To: City of Riverside Planning Division of CEDD via Principal Planner Brian Norton

From: Friends of Riverside's Hills

Re: Public Comment on PR-2021-00119 (Grading Exception), 6500 Hawarden Dr.

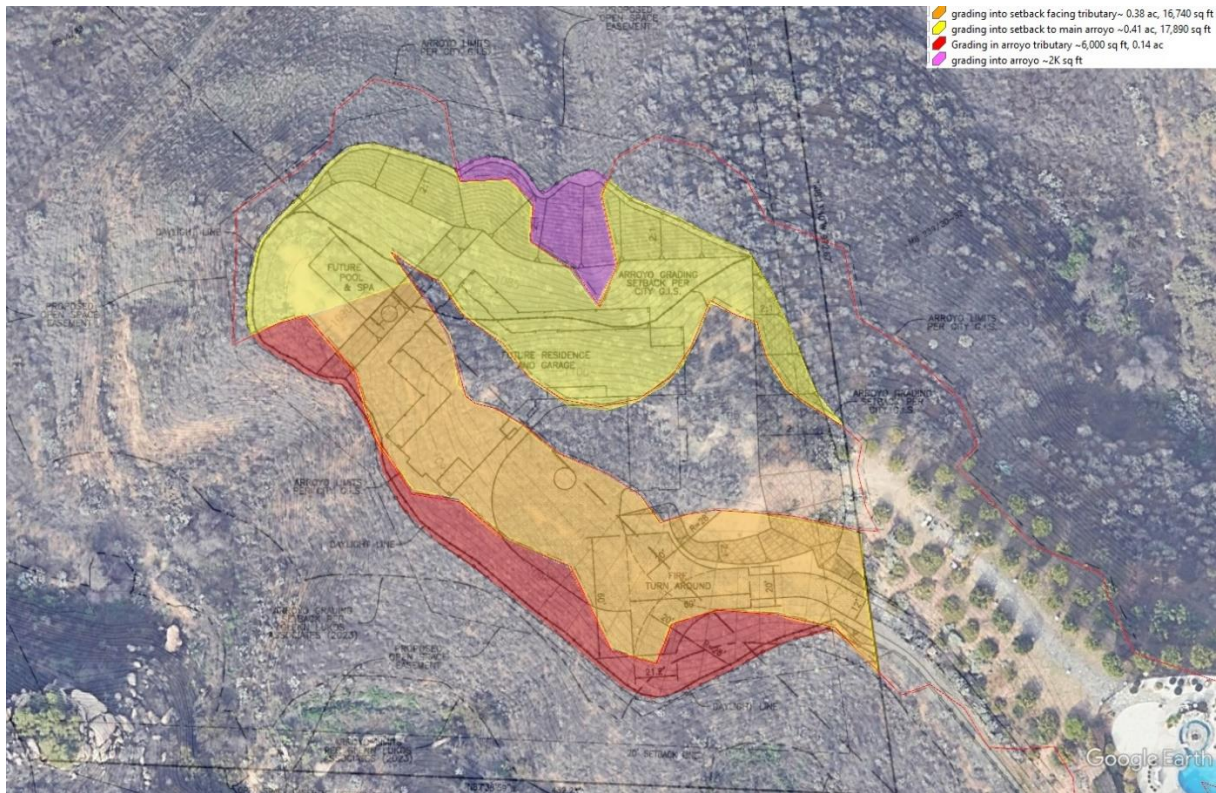
It is the City ordinance that defines the extent of the Alessandro Arroyo, and not Mr. Gurthrie's biological consultant Glen Lukos Associates (GLA). That ordinance, including that map, can only be changed by action of the City Council; any attempt by Mr. Guthrie, GLA, or staff to change the definition/map of the Alessandro Arroyo appears to us to be an attempted usurpation of the authority of the City Council. That attempt to use a different definition of the Alessandro Arroyo is exemplified in the Conceptual Grading Plans, where there are dashed line boundaries labeled "Arroyo Limits Per Glen Lukos Associates (2023)" and "Arroyo Grading Setback Per Glenn Lukos Associates (2023)", which differ greatly from the dash-dotted line boundaries shown there as "Per City G.I.S."

This (and the required Grading Exception Findings Justifications, examined below) shows that the applicant and his consultants are regarding the portion to be disturbed that is located within the boundaries of the City-mapped Alessandro Arroyo as being within an Alessandro Arroyo **tributary**. But that is incorrect. Indeed, the only tributary mentioned in the Guthrie letter, and repeatedly referred to in the GLA report as Feature 1, is a tributary south-southwest of the proposed graded area (“Project Footprint”) and shown in that report’s Exhibit 7, with the Riparian area shown there in green and a 50 foot buffer from that shown there in purple. As one can see from that Exhibit, only a fringe area of the Project Footprint faces the tributary and the bulk of the Project Footprint faces toward what the Exhibit 7 calls Riparian or Riverine areas, that is, parts of the Alessandro Arroyo and not the tributary. This is shown most dramatically in GLA Exhibit 3, an aerial photo with the Project marked on it, where one can see that the northern part of the Project Footprint faces the Arroyo’s main watercourse directly to its north and northwest, and not toward any tributary. This is shown explicitly in the figure below (next page).

The final page of the Conceptual Grading Plans has diagrams showing the proposed graded areas within the Arroyo (as defined in the Grading Code) itself (marked as 1,769 + 892 SF) and those within the tributary, the latter area being a small fringe along the south and southwest of the Project Footprint marked as 4,721 SF, and the “Graded Area Within City Defined Arroyo Grading Setback = 40,362 SF”, which, with the addition of the areas within the City-defined Arroyo (rather than in its setback, brings it close to a whole acre of land to be graded despite the Code prohibition of such grading. This is shown in more detail in the previous page of the Conceptual Grading Plans, with dash-dotted lines showing “Arroyo Limits Per City G.I.S.” and “Arroyo Grading Setback Per City G.I.S.”. It also shows much less inclusive areas of these Arroyo and Setback boundaries “Per Glenn Lukos Associates”.
